January 27, 2023

Re: 4401 Alexander Blvd NE
Site Plan – DRB Re-Submittal
Project Number: PR-2018-001252
Application Number SI-2022-02328

Re: Curia Building Addition
4401 Alexander Blvd NE Albuquerque, NM 87107
Grading and Drainage Plan (F16D003B1)
Letter of Response

| DRAWING NUMBER: | CS100 | SIZE: | E1 | |

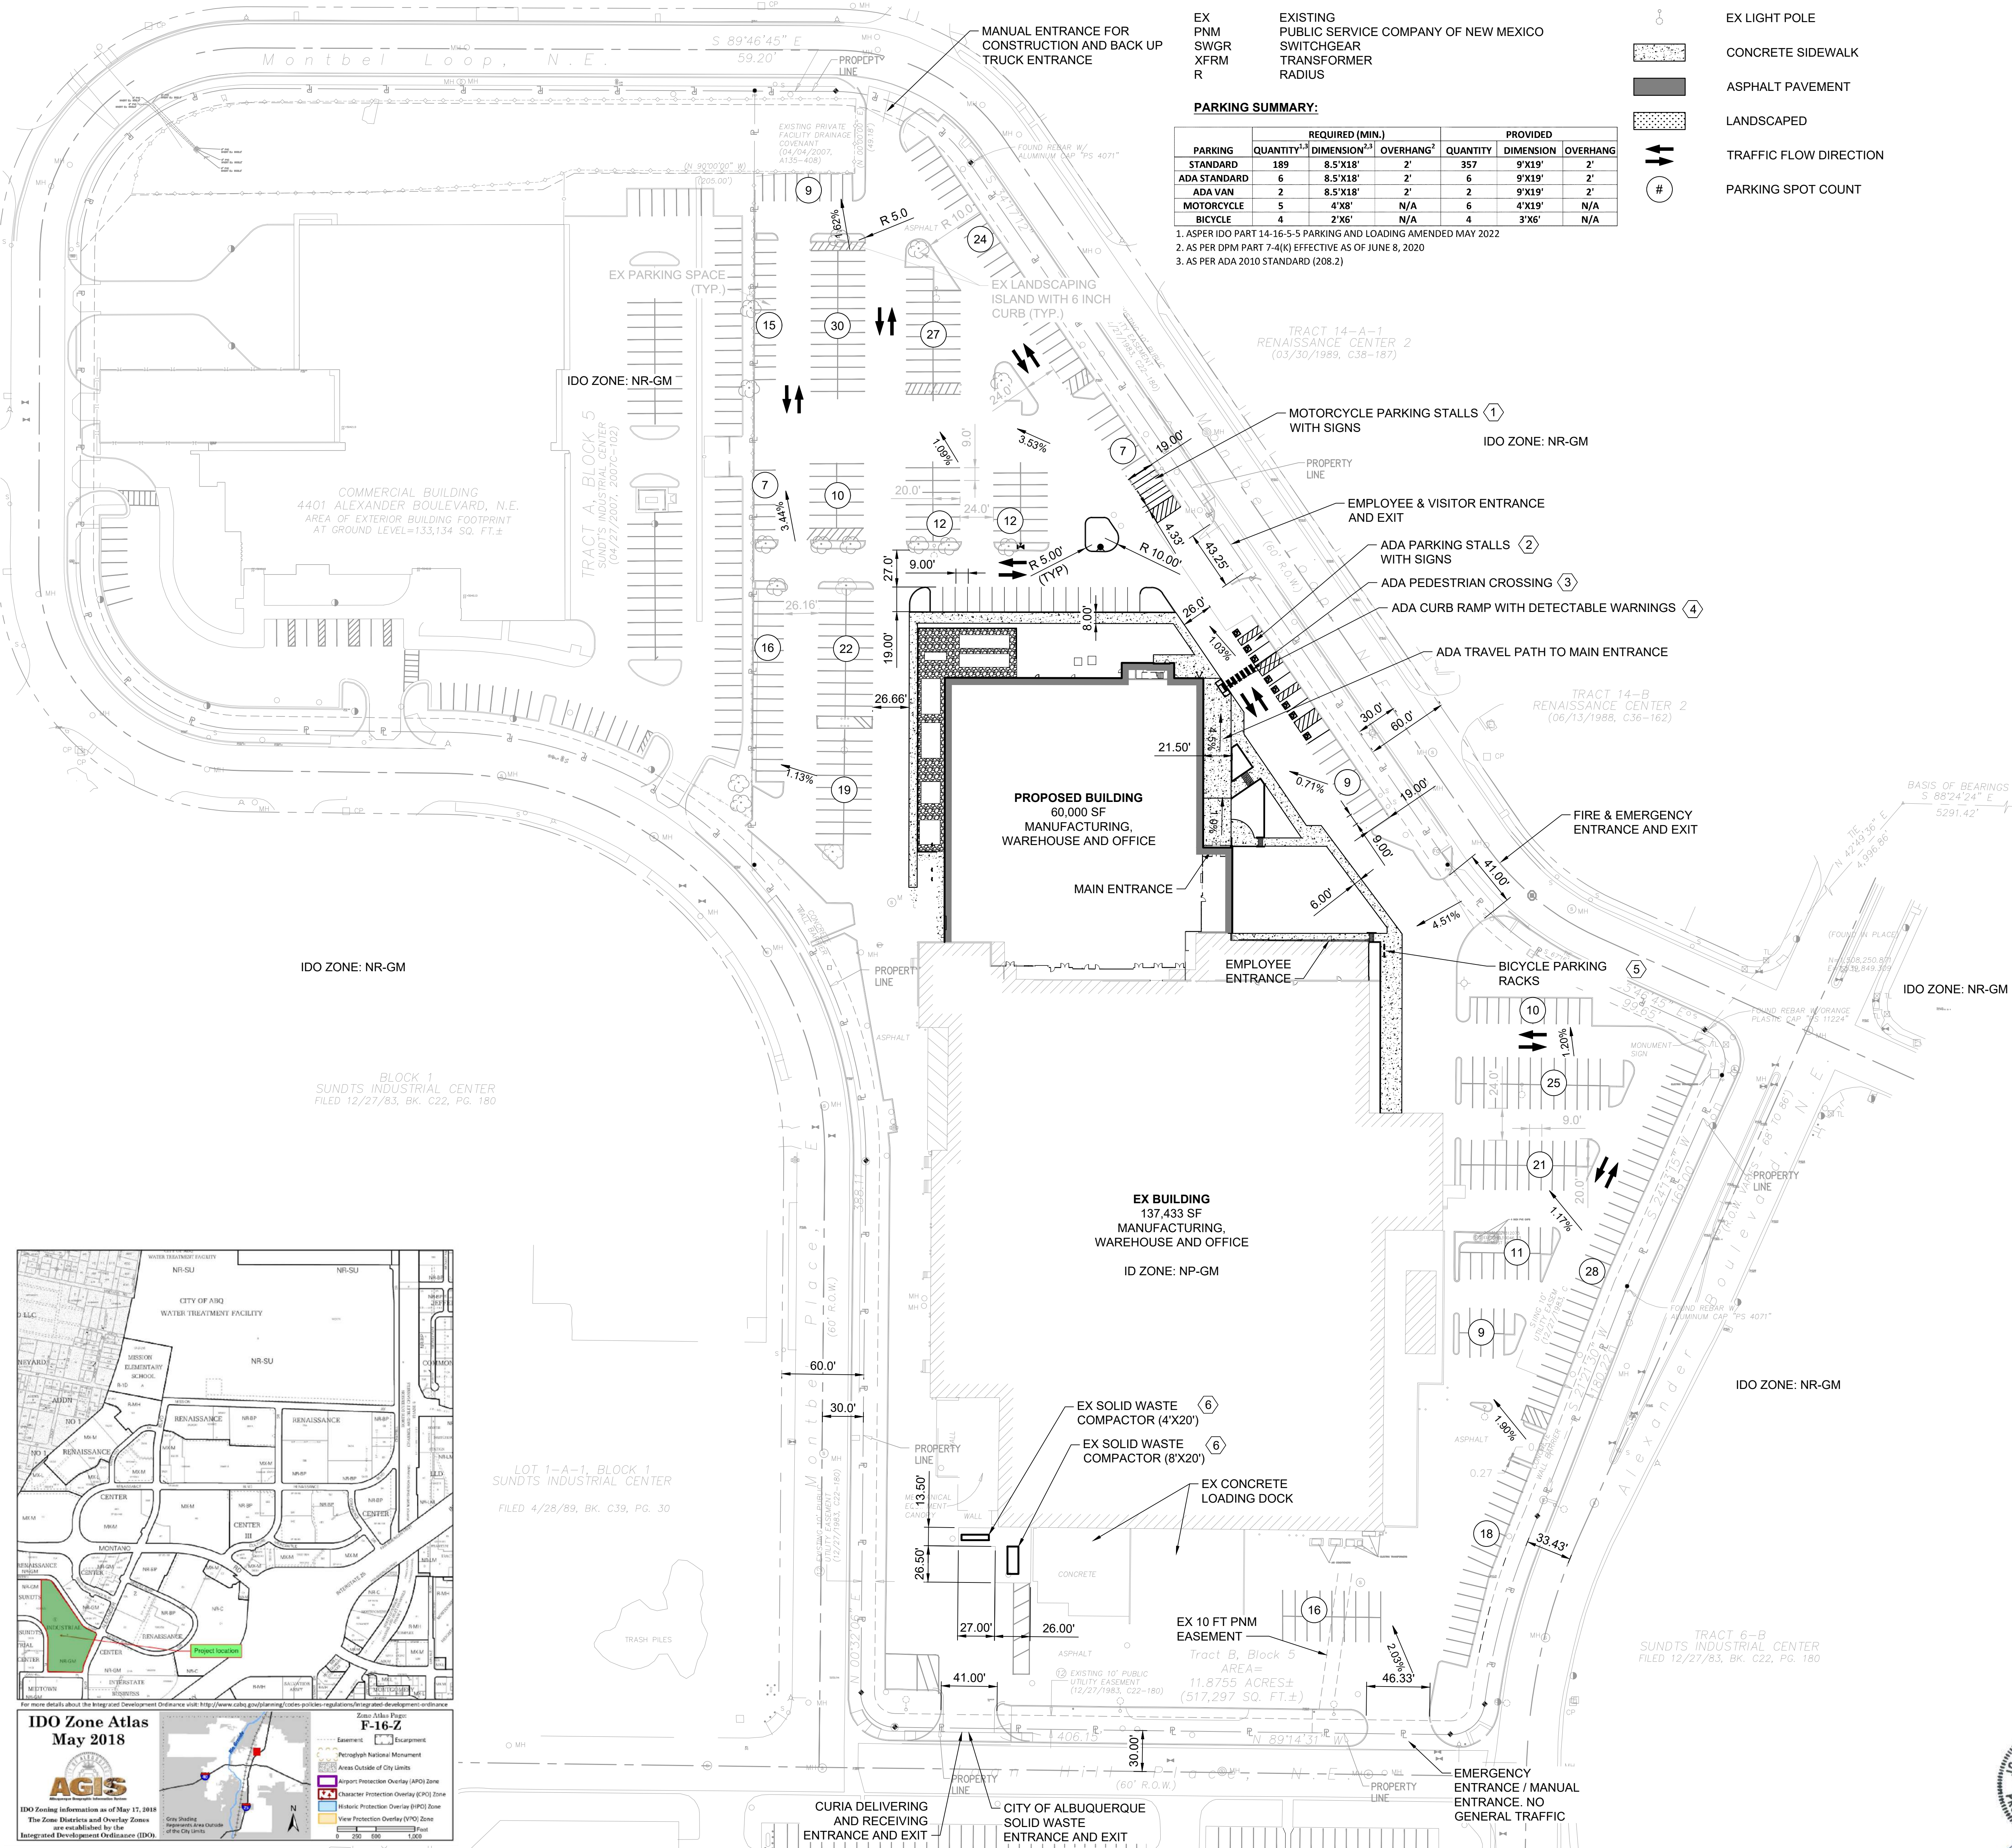
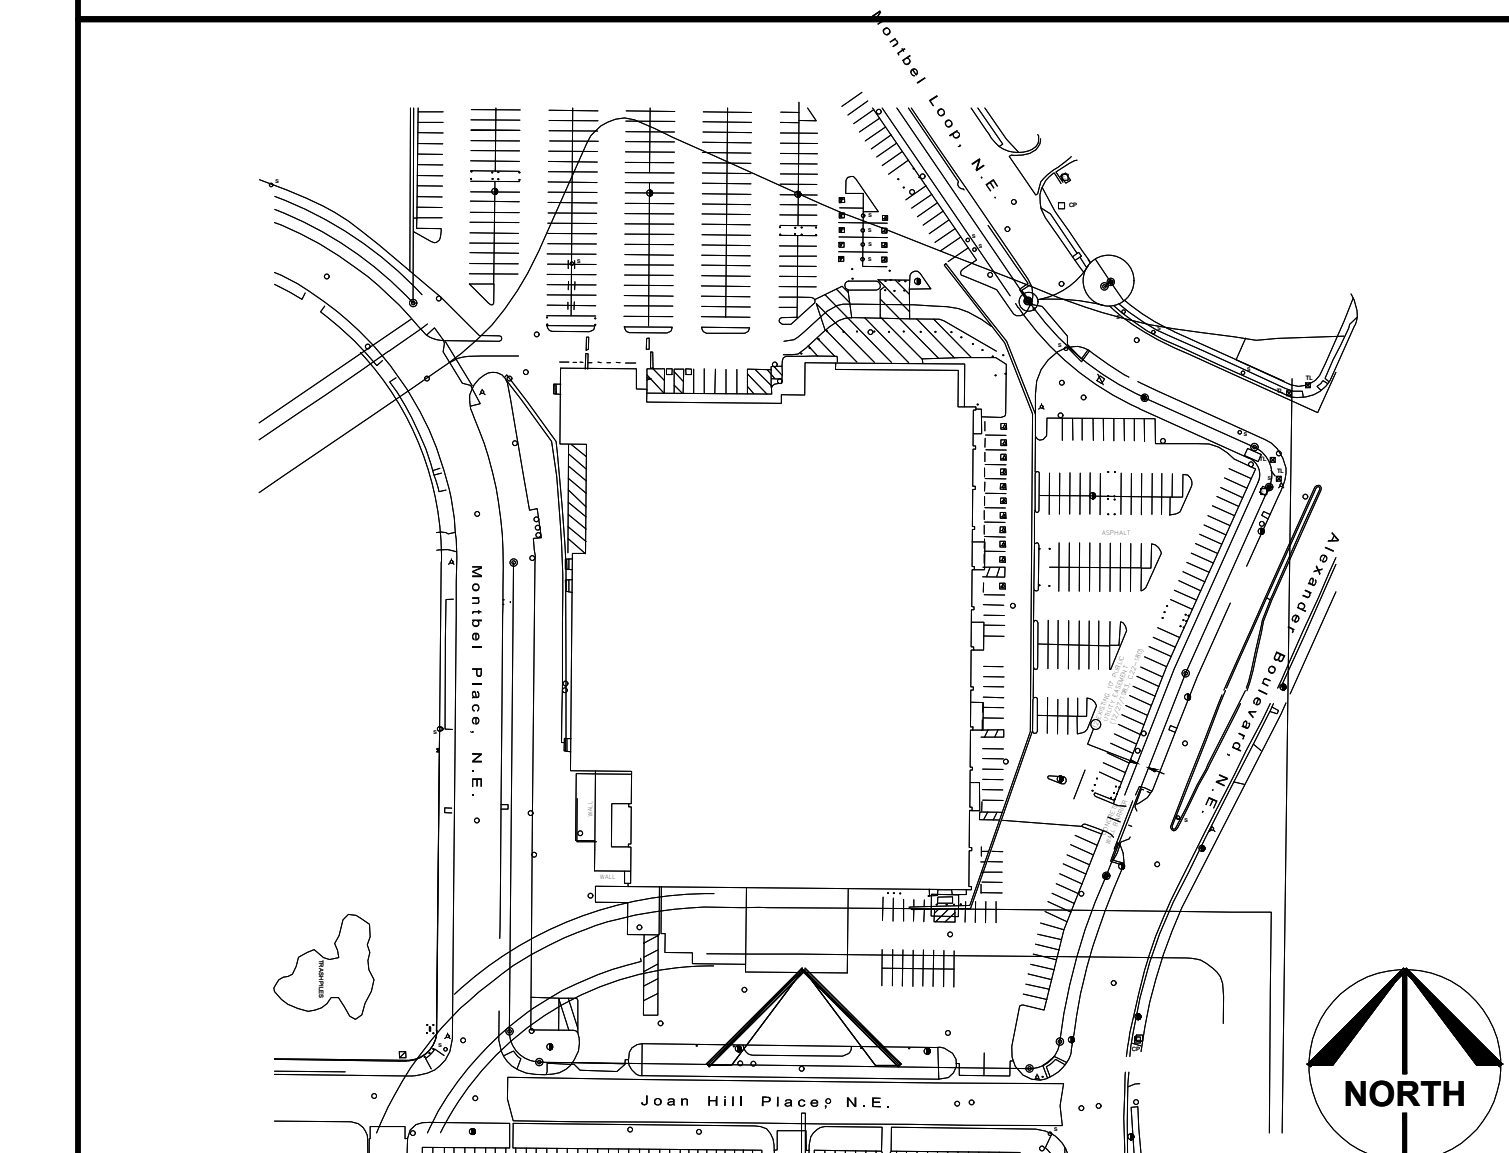
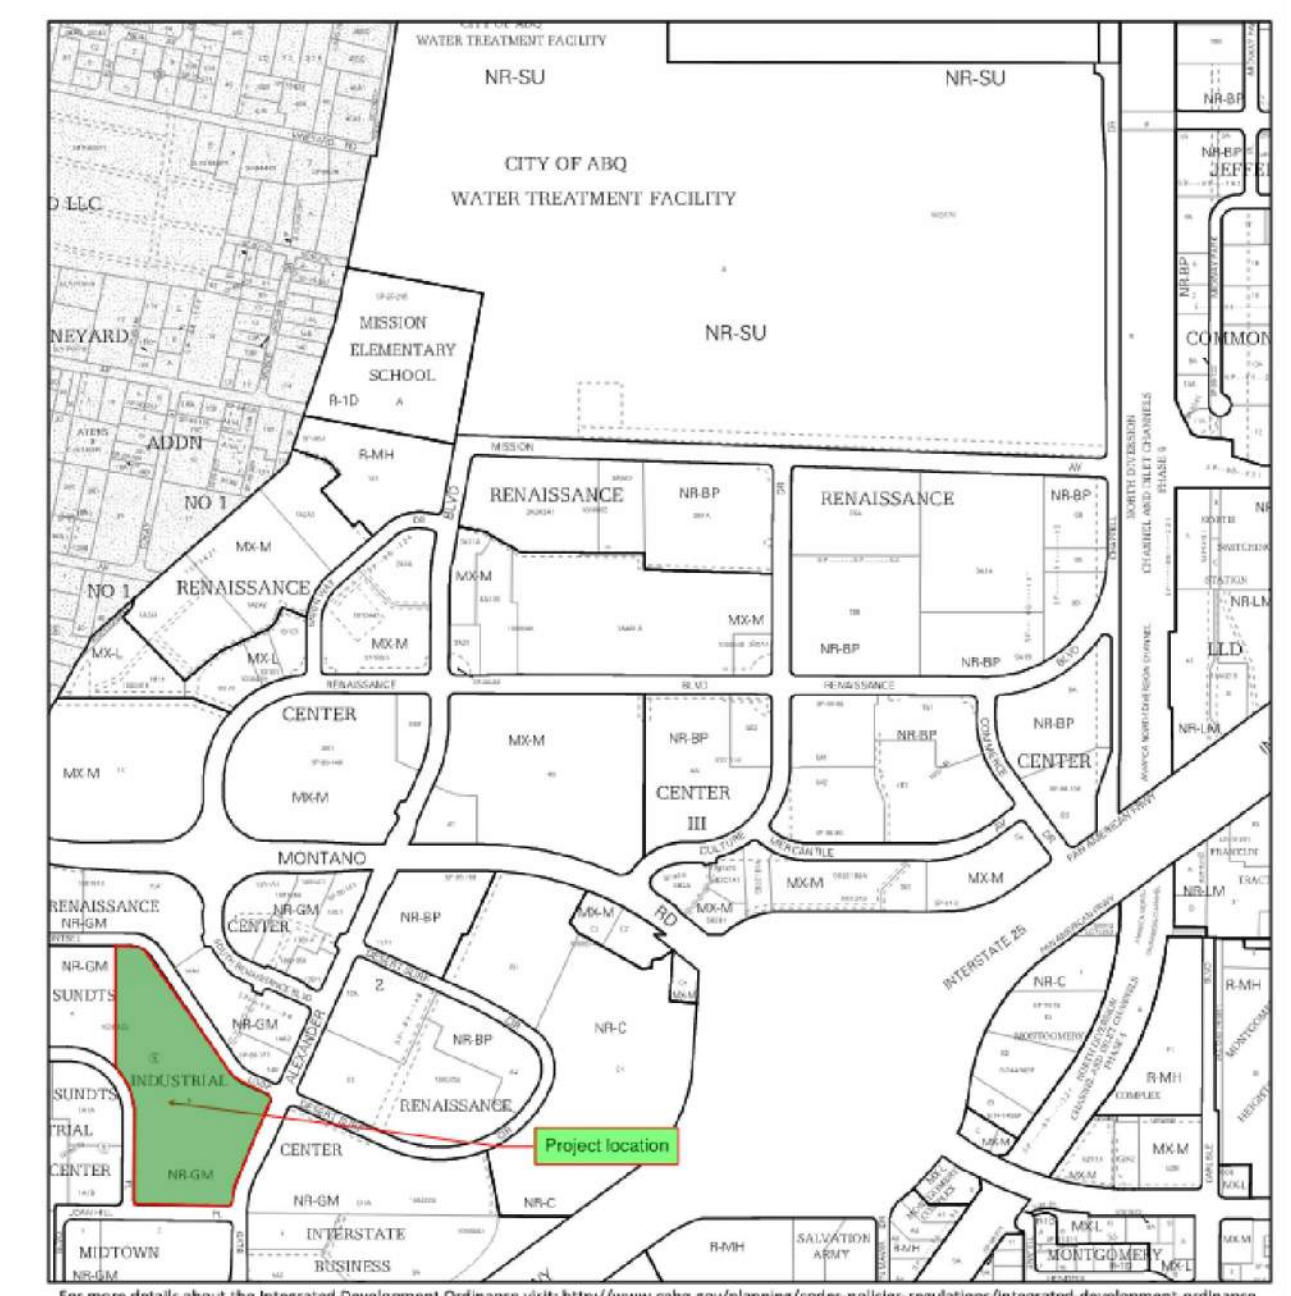
6. Need to show the various square footage types of use in all buildings, both old and new. Must show detailed, combined parking calculations based on each of those specific use requirements, as per IDO section 5-5(c), Table 5-5-1, including total required and provided.
 - a. Response: Refer to drawing number CS100.
